SB-935

## SERVICE BULLETIN AMATEUR RADIO

SUBJECT	DATE
TM-321A LOSS OF TX AUDIO WITH MC-48B	6/02/88

FIGURE 1

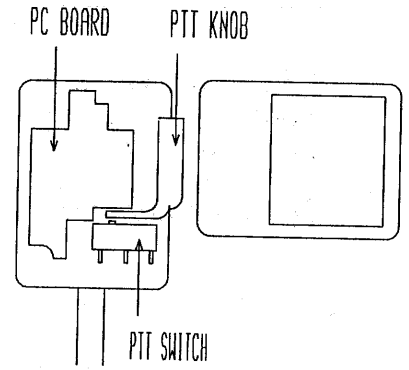
1. Remove the 3 screws from the mic case (Figure 1). Carefully open the case.
2. Pull the PC board, PTT knob, and PTT micro switch out of the mic case to expose the mic element cover (Figure 2).
3. Remove the 3 screws and mounting clips (Figure 3) securing the element cover. Remove the PTT spring. Pull the mic element and cover out of the case.
4. Remove the element from the rubber cover.
5. Install and solder the capacitor directly to the mic element terminals where the brown and white wires are connected (Figure 4). To avoid damaging the element, use a low wattage soldering iron.
6. Carefully assemble the mic by reversing steps 1 - 4.
